Pooks Hill Site Plan Amendment No. 81982098F

Completed: 09.11.2020

- Staff recommends **Approval** of the Site Plan Amendment, with conditions.
- The Site Plan covers the entire Site totaling 19.38 acres, which comprises two condominium units: Hotel Unit (existing Bethesda Marriot Hotel) and a Multi-Family Unit (this Amendment).

Figure 7: Proposed Green Area

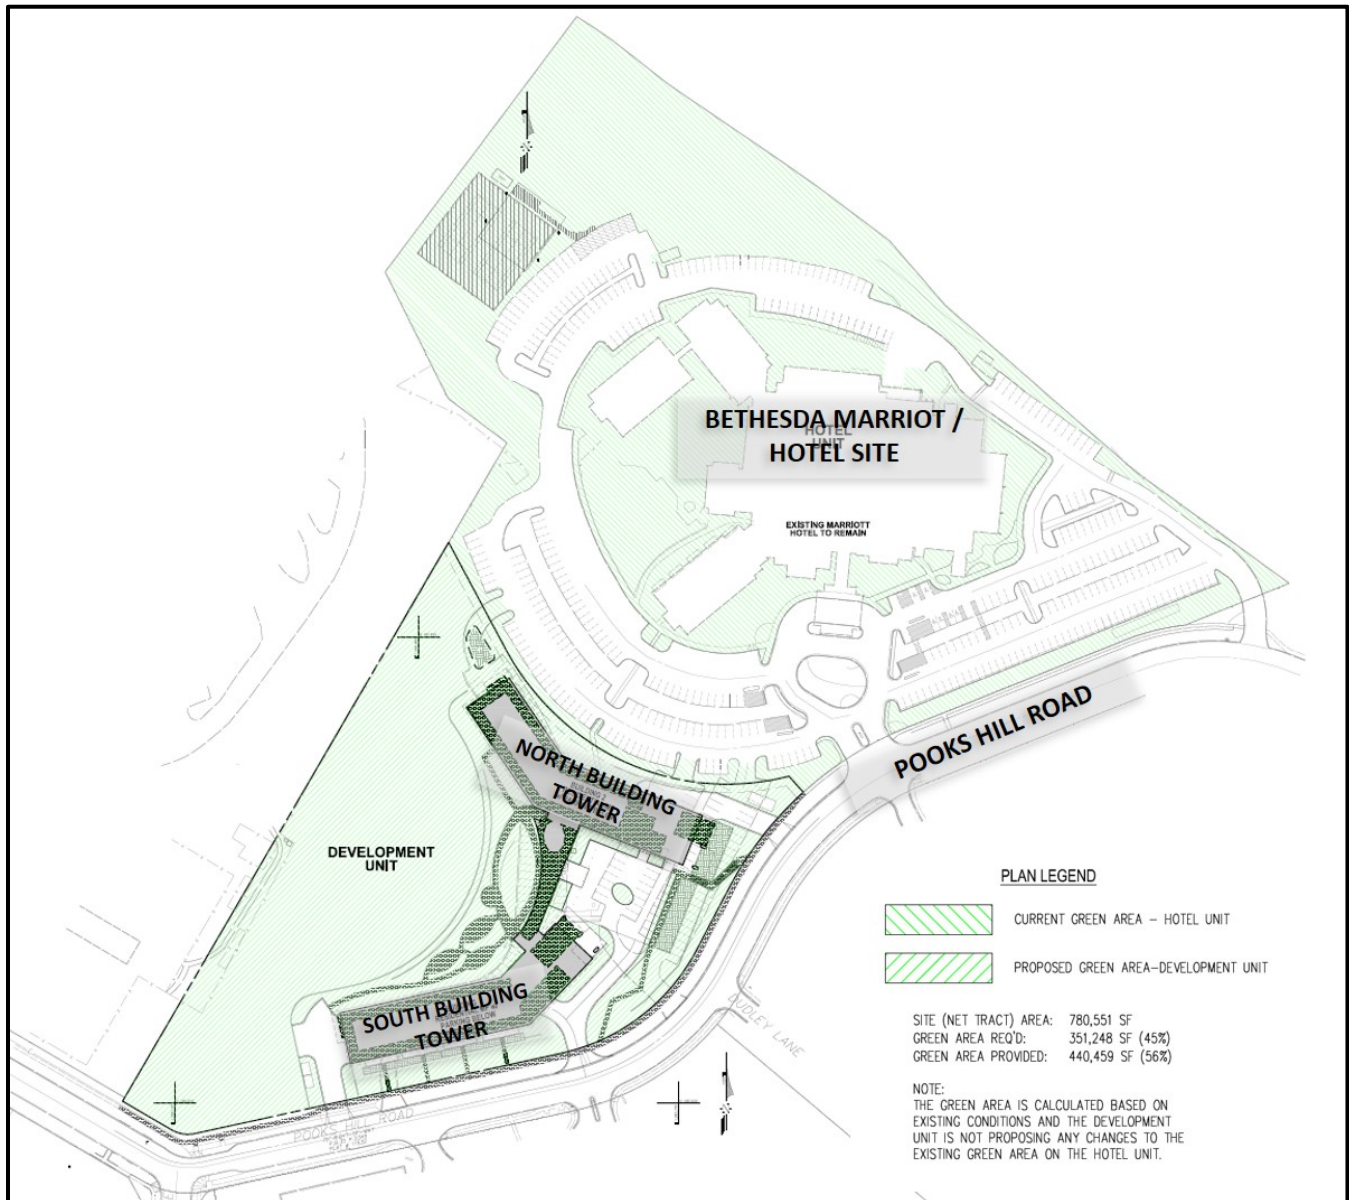
Therefore, the Applicant is not required to provide open space but is required to provide green area in the amount of 45% of the net lot area (19.38 acres). The previous approval provided 426,888 square feet (55%) and this Amendment proposes 440,459 square feet (56%) which satisfies this requirement. The green area remains mostly unchanged from the previous approval, and the increase in square footage is a result of reorienting the Site's circulation to allow a more cohesive amenity space in the rear of the newly proposed lobby link.

Figure 9: Approved Site Plan 81982098C Circulation (Left) vs. Proposed Site Plan Circulation (Right)

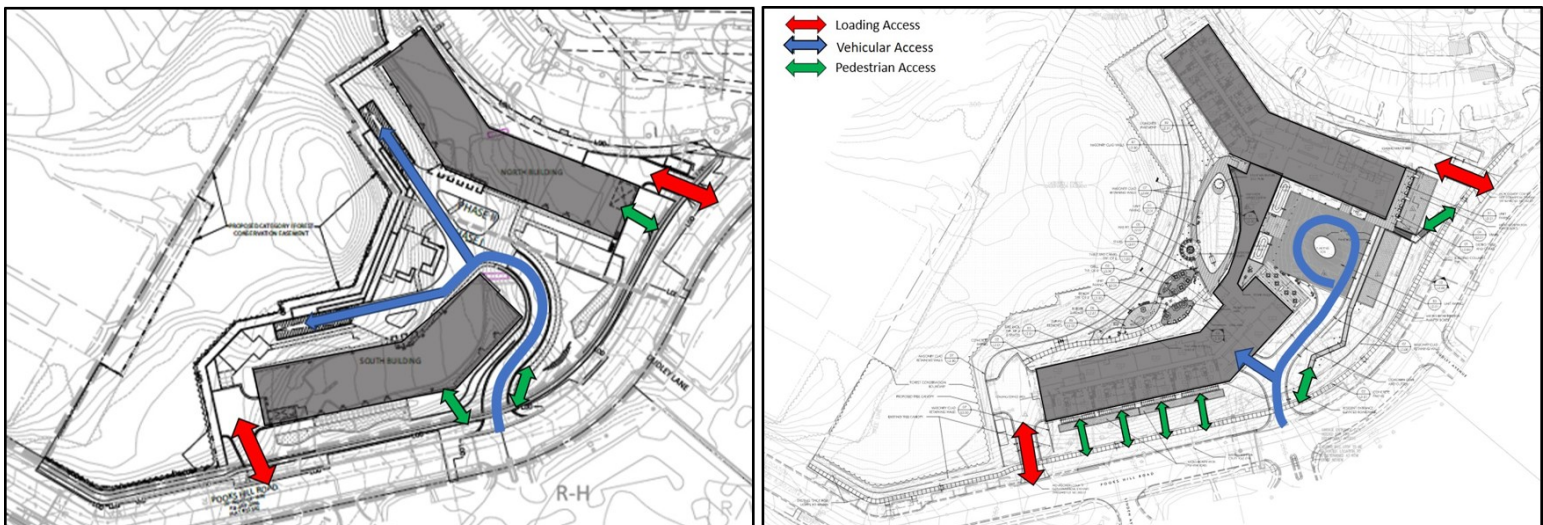
The Amendment reconfigures the entrance of the parking garage for the two towers into one location which removes vehicles from the rear of the site, enhances the rear amenity space, and increases the safety and circulation patterns for pedestrians. A circular driveway ("arrival court") near the lobby entrance will remain accessible to pedestrians and to motorists to allow for access as well as drop-off and pick-up activities.
